NUMBER: 10-003-16

Rear Outboard Seat Belt Is Slow To Retract

2016 (FB) Fiat 500X

Fig. 1 Seat Belt Retractor

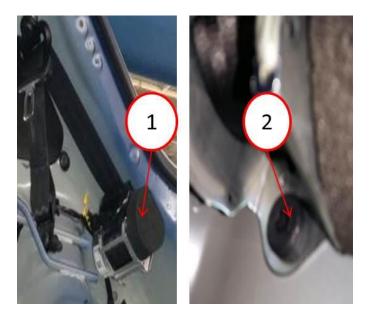
2. Remove the seat belt bolt that secures the retractor to the quarter inner panel (Fig. 1).

3. Add a washer on the bolt between the bolt and seat belt retractor (Fig. 2). Tighten to 40 N·m (30 ft. lbs).
